Re: Oconee Nuclear Station
Docket Nos. 50-269, -270, -287

Pursuant to 10CFR50, §50.90 and in response to IE Bulletin 79.05B, Item 7, please find attached a proposed amendment to the Oconee Nuclear Station Facility Operating License. This request revises Oconee Nuclear Station Technical Specification 2.2, Safety Limit-Reactor Coolant System Pressure, and Specification 2.3, Limiting Safety System Settings, Protective Instrumentation.

OCONEE NUCLEAR STATION
PROPOSED TECHNICAL SPECIFICATION REVISION

Figure 2.3-1A

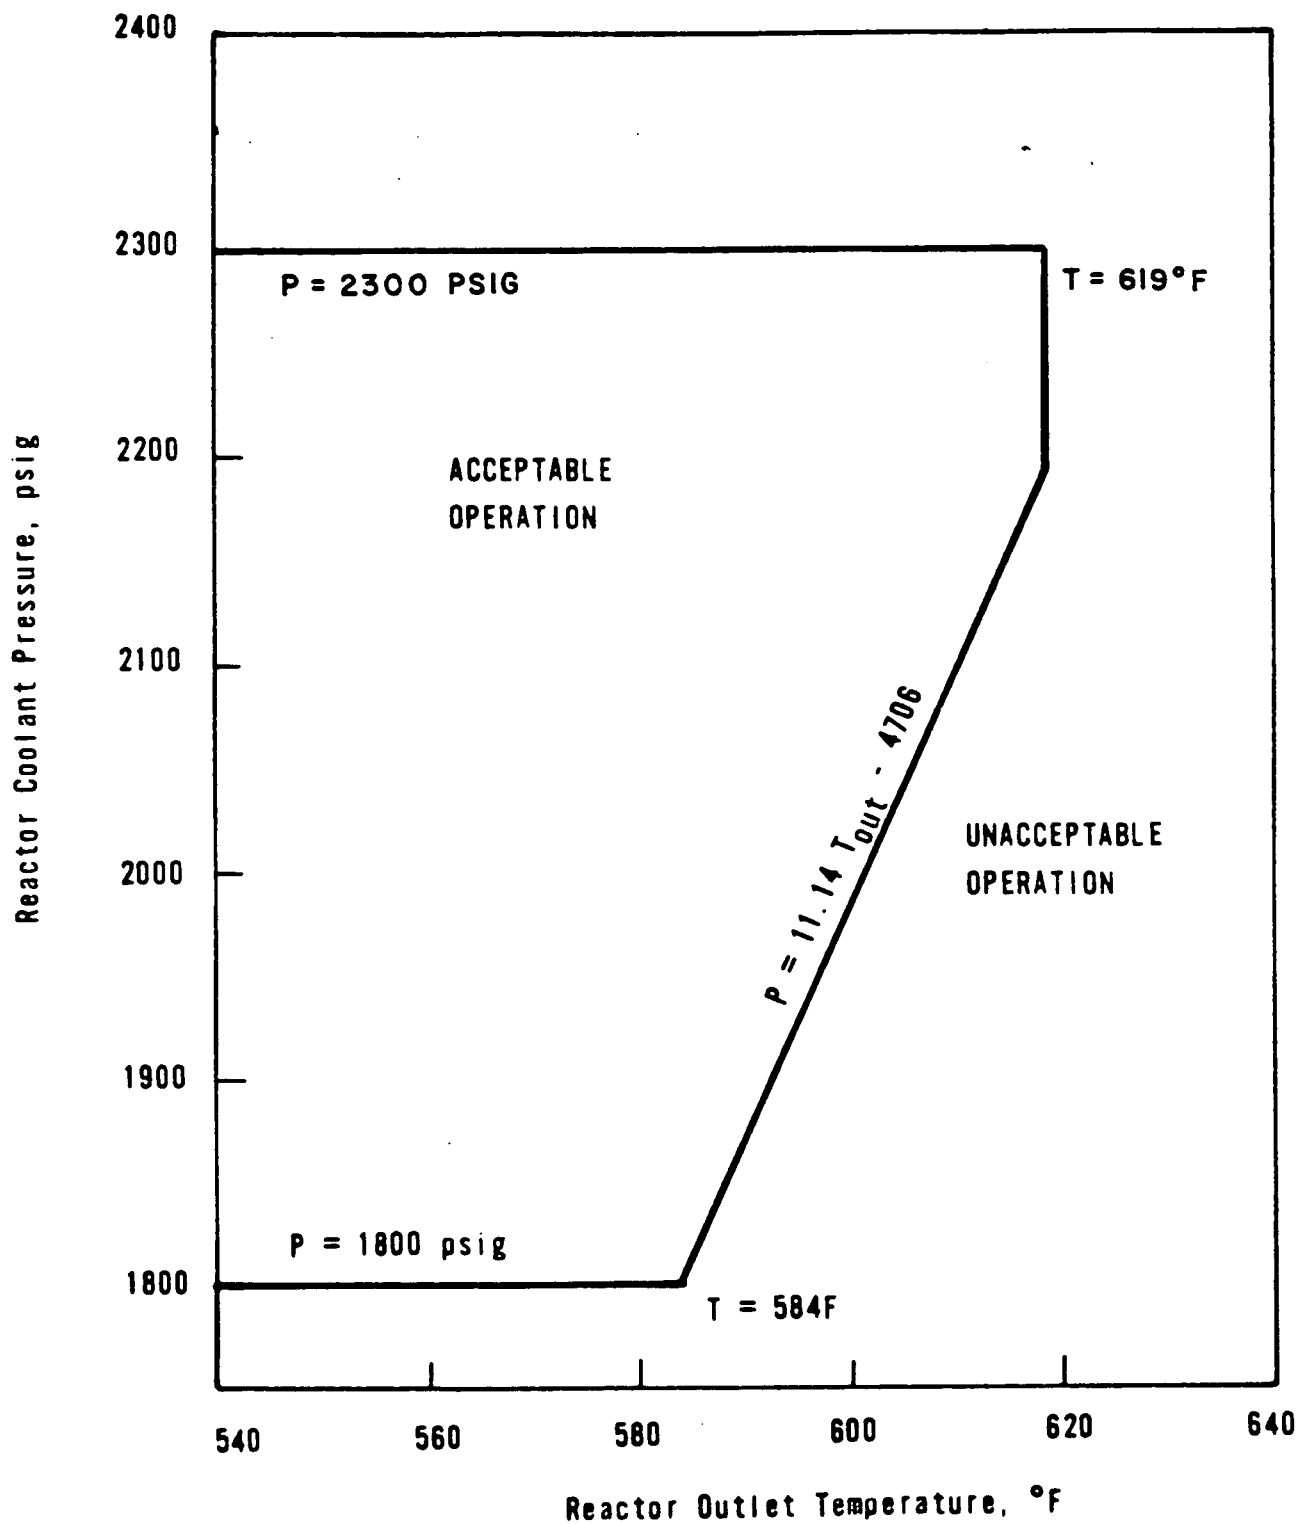
This proposed revision reflects recent changes to the setpoints of the pressurizer electromatic relief valve and the reactor coolant system high pressure trip made in response to IE Bulletin 79-05B.

During a startup accident from low power or a slow rod withdrawal from high power, the system high pressure set point is reached before the nuclear over-power trip set point. The trip setting limit shown in Figure 2.3-1A - Unit 1

for high reactor coolant system pressure (2300 psig) has been established to maintain the system pressure below the safety limit (2750 psig) for any design transient. (1)

PROTECTIVE SYSTEM MAXIMUM
ALLOWABLE SETPOINTS
UNIT 2

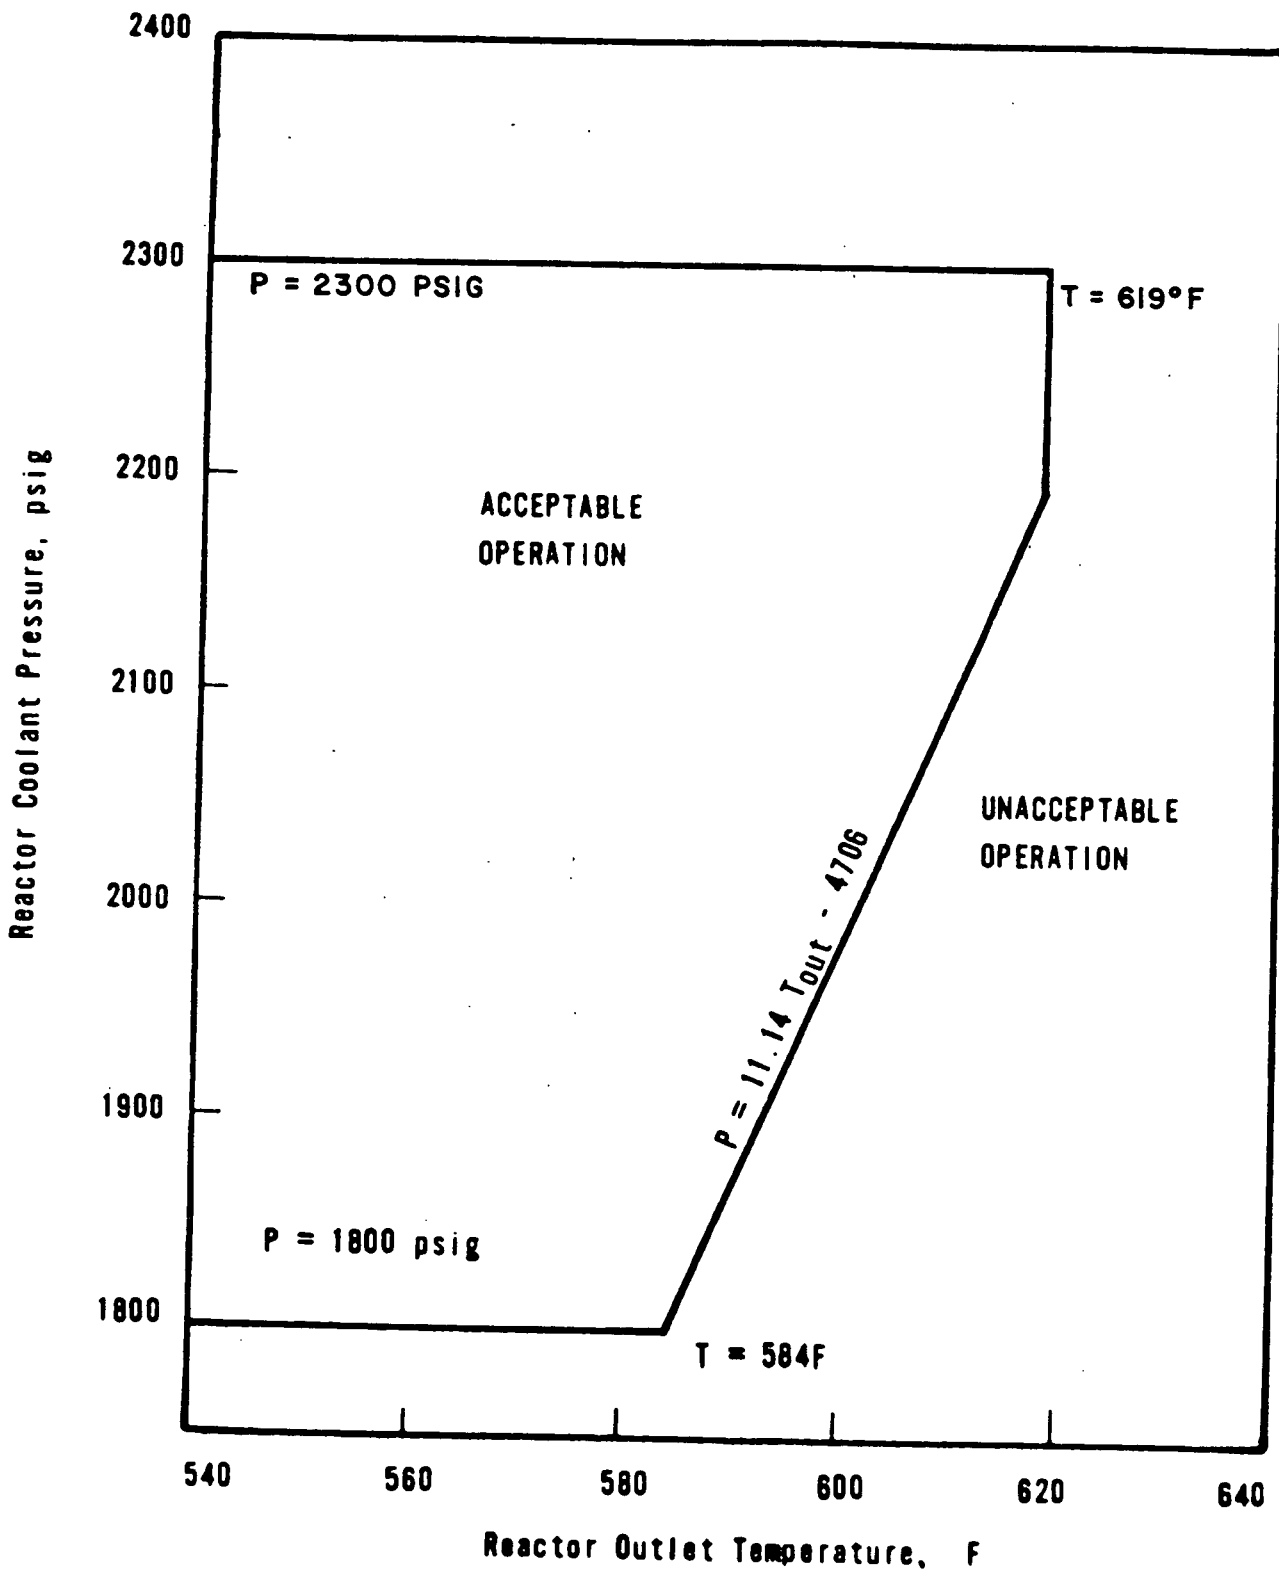
- 2.3-1B - Unit 2
- 2.3-1C - Unit 3
